Property Alliance Group / Starwood Capital Group Renaissance Site

Residential Building Section 73 Application (141175/JO/2024)

Issue No. 03 23.10.25

5.3 East Elevation
S73 Proposal

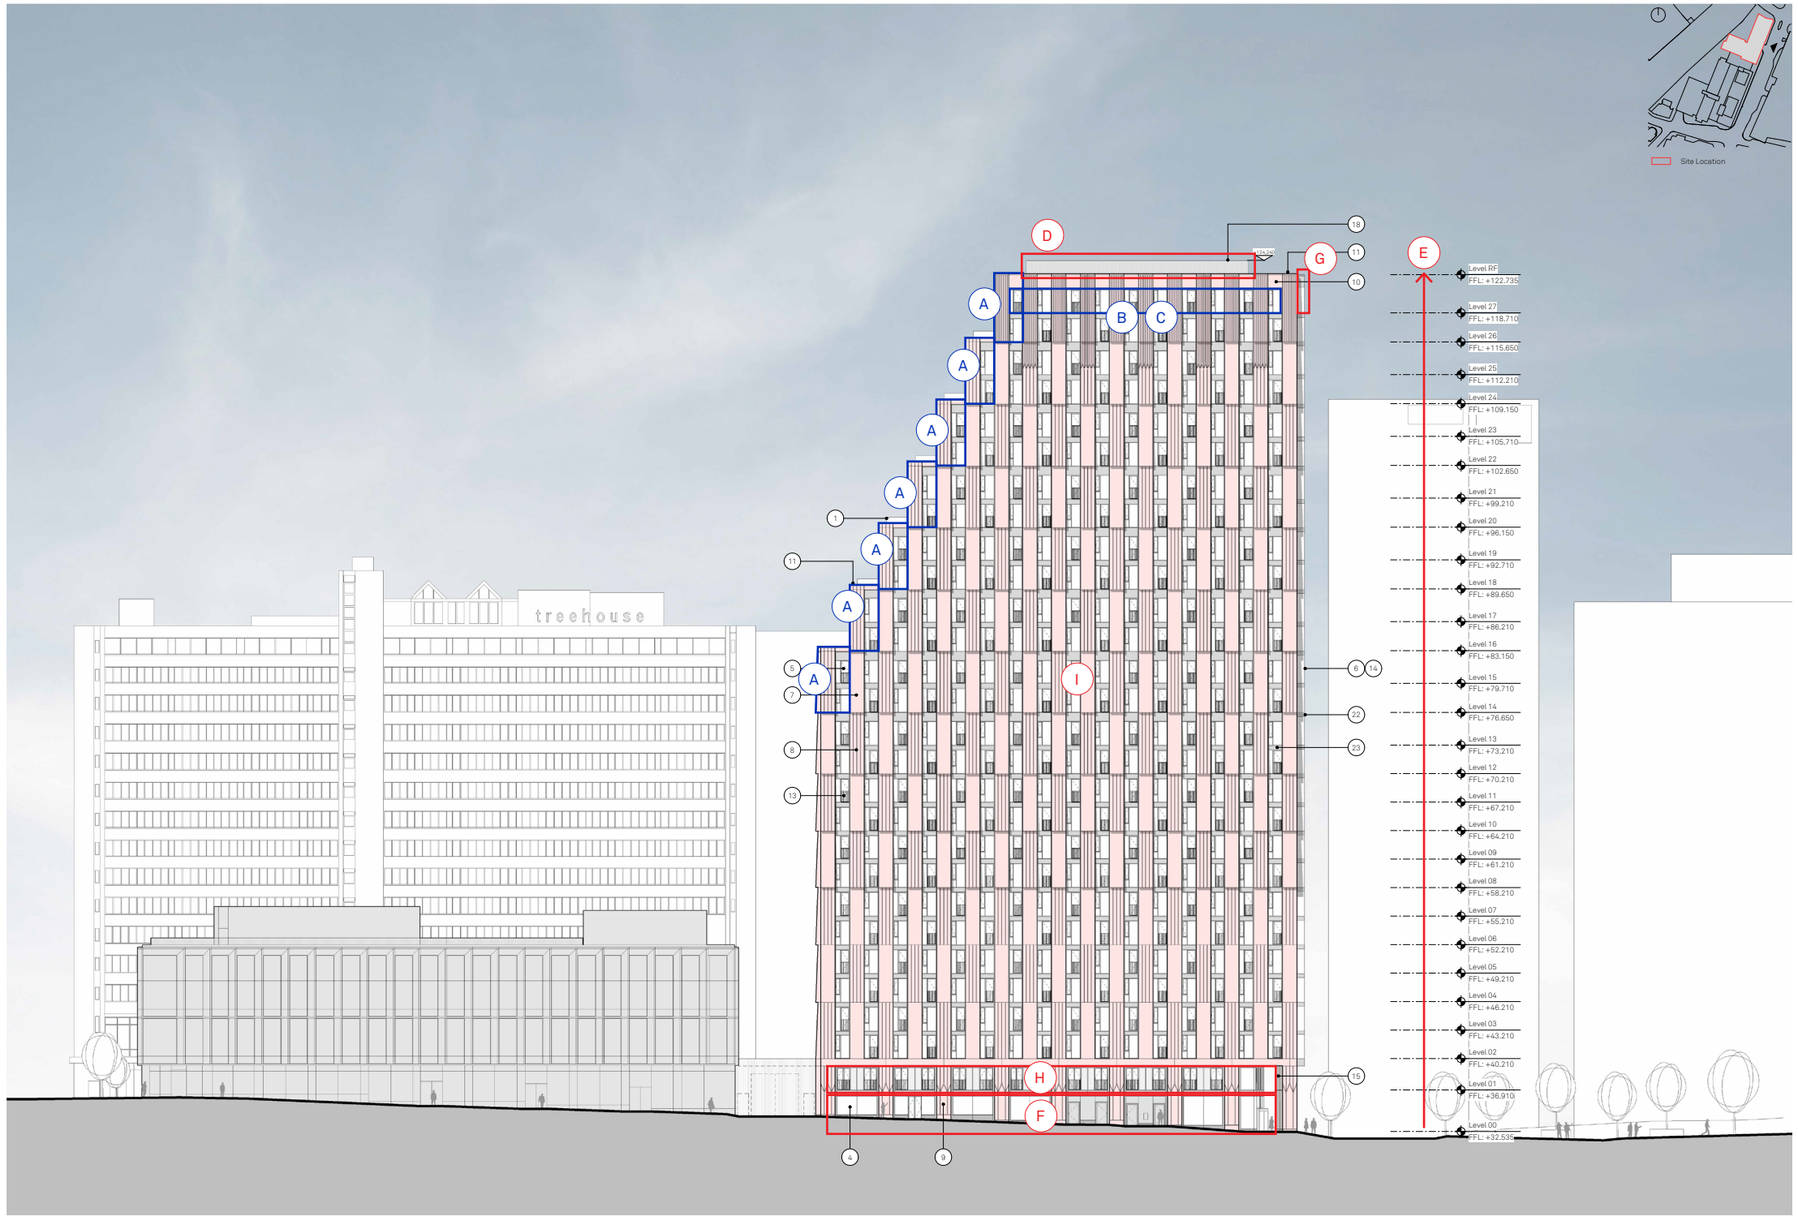
A. Internal floor plate extended into previous / consented external terrace area floors 14-27. Scale, massing and elevation amendments proposed where the floorplate is extended.
B. New upper floor duplex accommodation added to level 27.
C. New glazing added between precast to level 27.

D. Vertical metal fins added on the top roof for air conditioning condensers and smoke extrat fans. The plant enclosure is recessed from the main facade to mitigate view impact from street level.

G. Duplex terrace on level 27th has been ommited to consolidate the volume and elevation facing the Cathedral.
H. Added Juliet balcoines to Ground floor CW systems to achieve a more unified street level facade and to suit amended internal layouts.

5.3 North & South Elevation
S73 Proposal

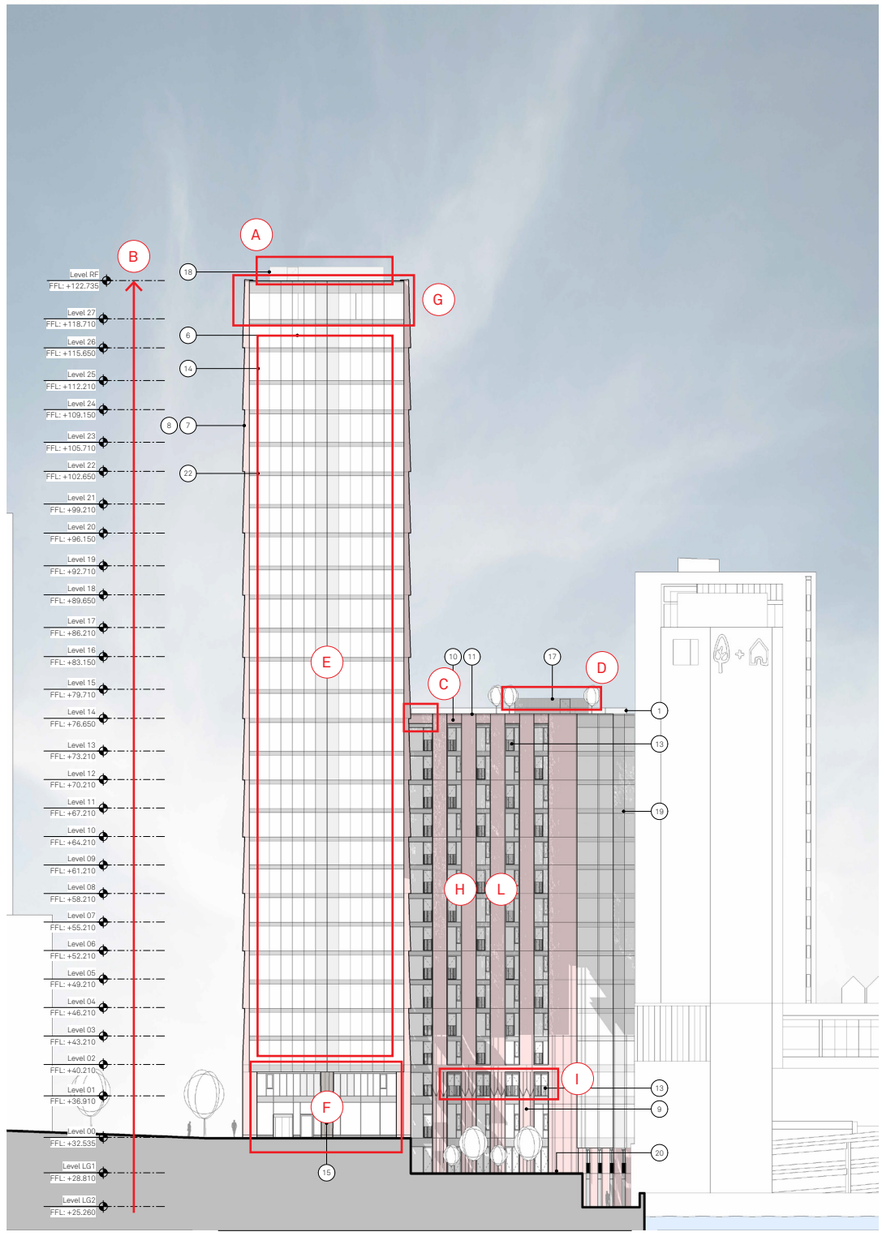
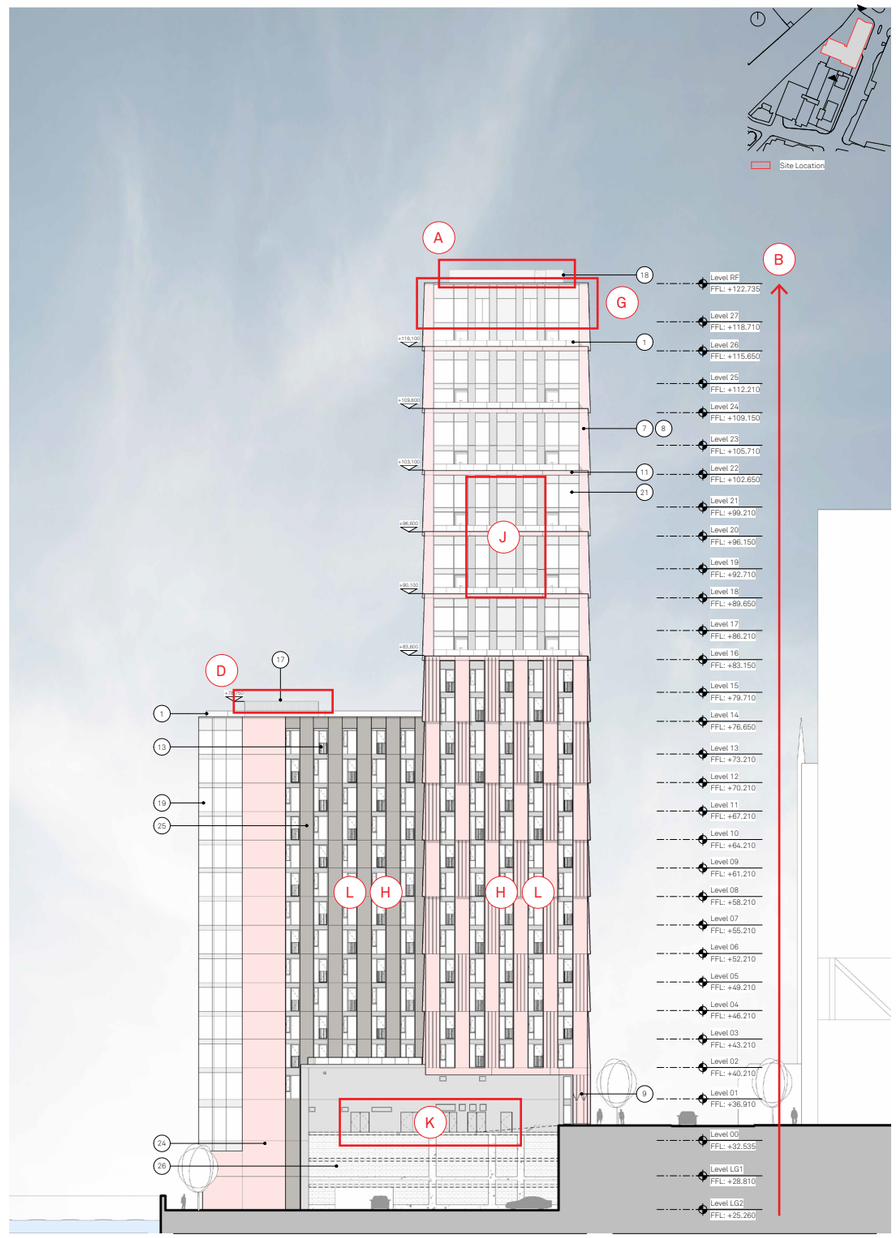
A. Vertical metal fins added on the top roof for air conditioning condensers and smoke extrat fans. The plant enclosure is recessed from the main facade to mitigate view impact from street level.

C. To reinforce the idea of a simpler volumen and to simplify the structure design, a precast lintel has been added connecting both blocks and simplifying the volume.

D. Metal rainscreen cladding with a bespoke perforated panel has been added to the level 14 residents roof terrace to conceal the smoke extract fan.
E. Design of the CW system (mullion arrangement) has been amended on Victoria Bridge St elevation to standarize glass panel sizes.

I. Added Juliet balconies to Ground floor CW systems to achieve a more unified street level facade.
J. Location of metal panels with bespoke perforated design on stepped terraces amended to suit new internal layouts and re-location of smoke extract fan on level 18.

5.3 West Elevation
S73 Proposal

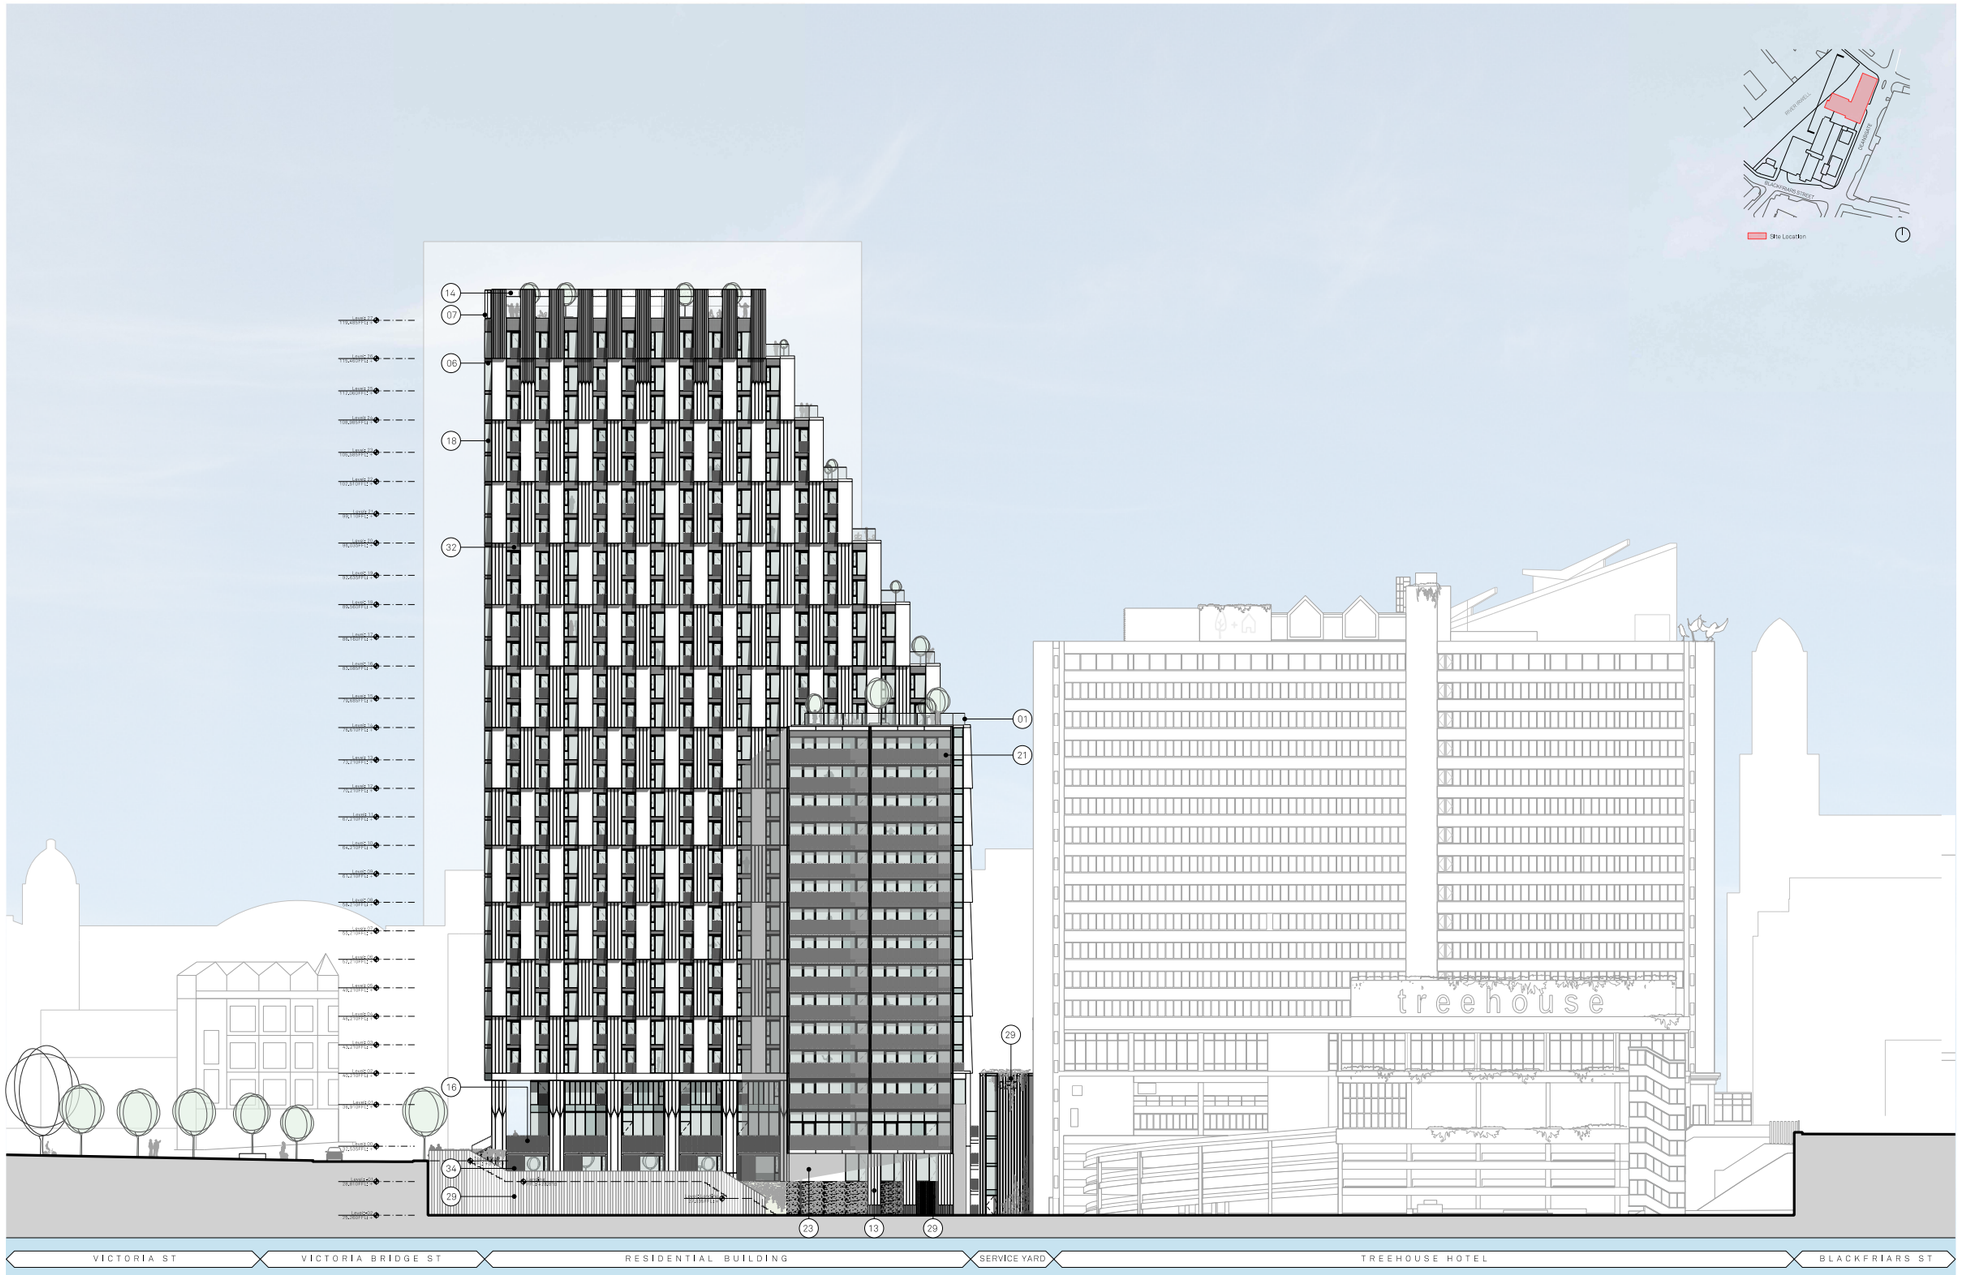
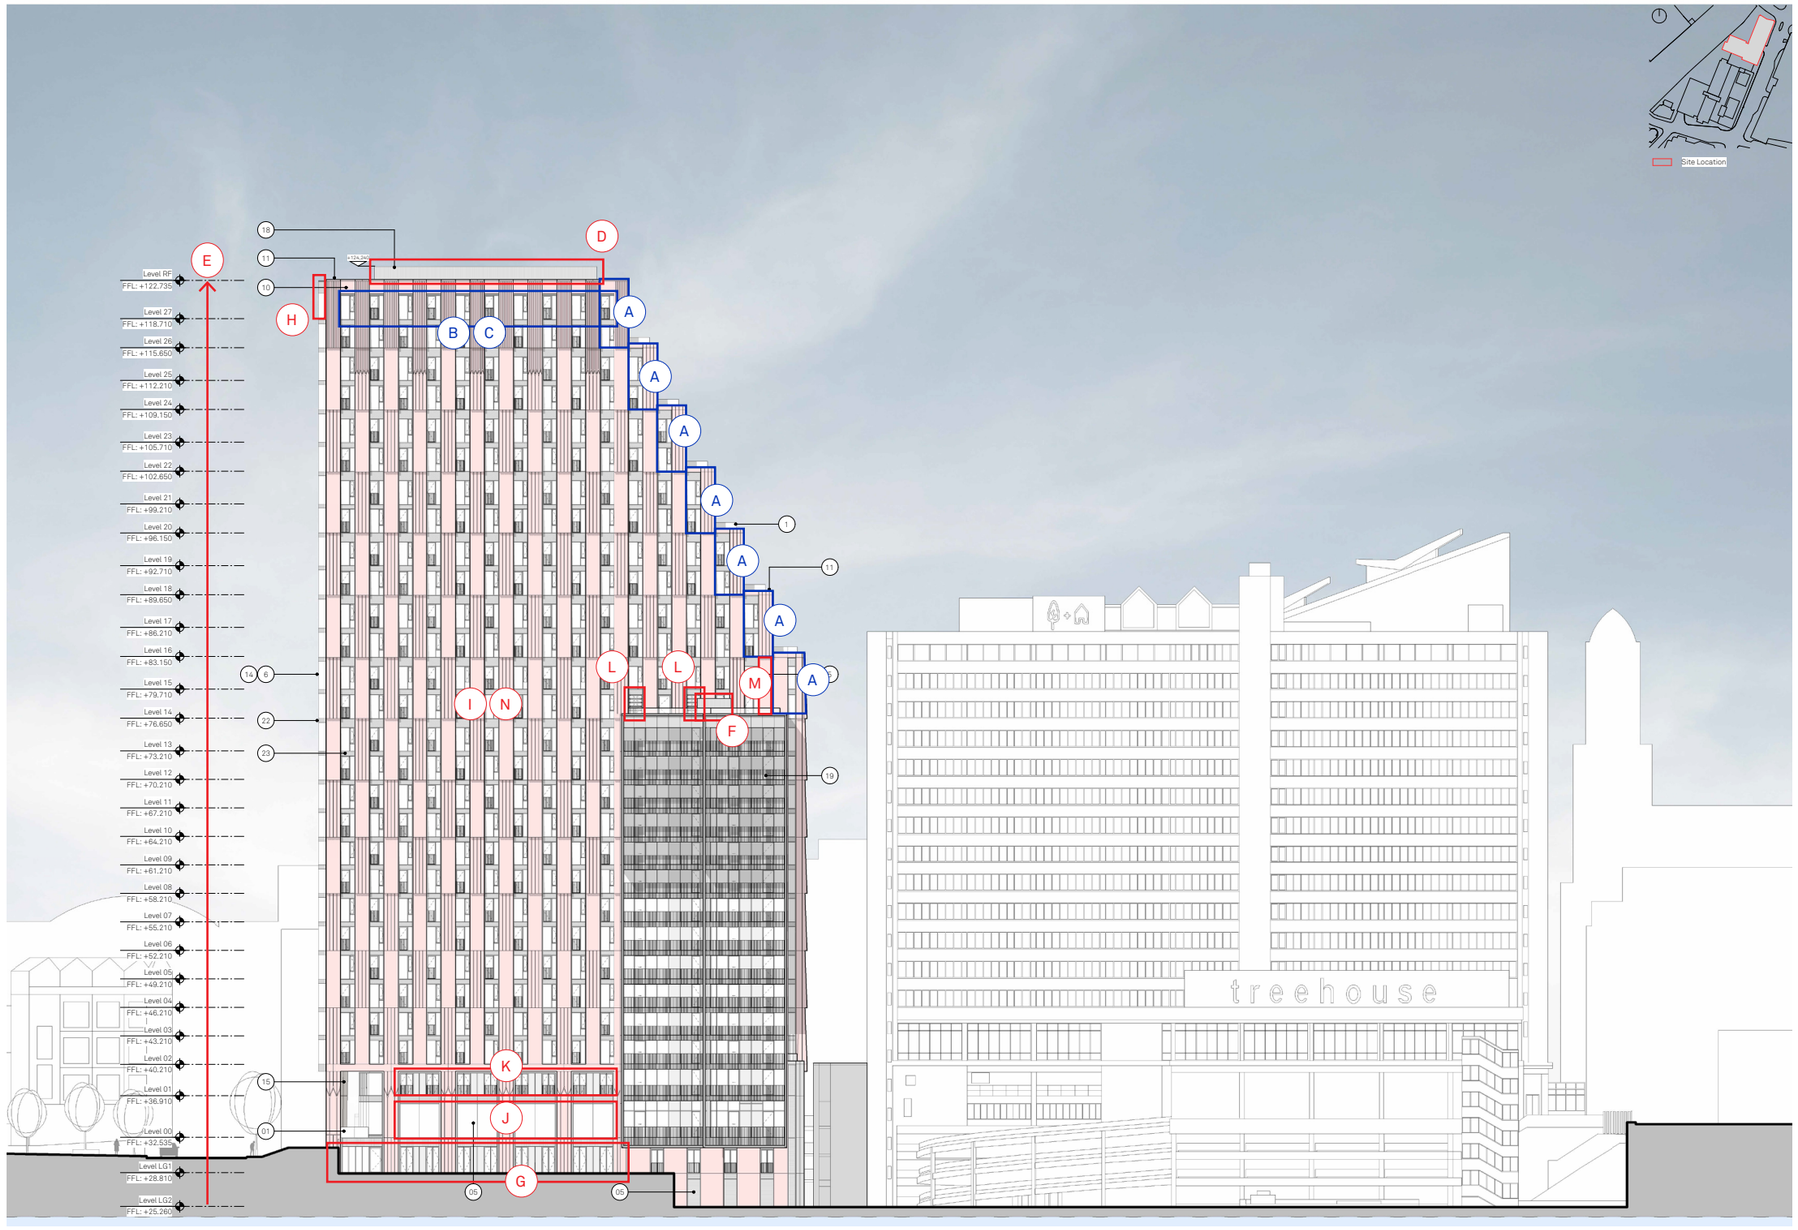
A. Internal floor plate extended into previous / consented external terrace area floors 14-27. Scale, massing and elevation amendments proposed where the floorplate is extended.
B. New upper floor duplex accommodation added to level 27.
C. New glazing added between precast to level 27.

D. Vertical metal fins added on the top roof for air conditioning condensers and smoke extrat fans. The plant enclosure is recessed from the main facade to mitigate view impact from street level.

F. Metal rainscreen cladding with a bespoke perforated panel has been added to the level 14 residents roof terrace to conceal the smoke extract fan.
G. Design of the CW system (mullion arrangement) on Deansgate and River Irwell elevation has been amended to achieve a more unified street level facade.

J. Removed Ground floor terrace facing River Irwell elevation on amenity areas to simplify detail, waterproof line and thermal line.
K. Added Juliet balconies to Ground floor CW systems to achieve a more unified street level facade.

L. Glass louvres added on CW system for air inlet to smoke shaft.
M. Wider precast panel to consolidate facade and simplify CW design.
N. Patterned ceramic frit glazed spandrel with glazed in slot ven replaced for anodized perforated metal panel.
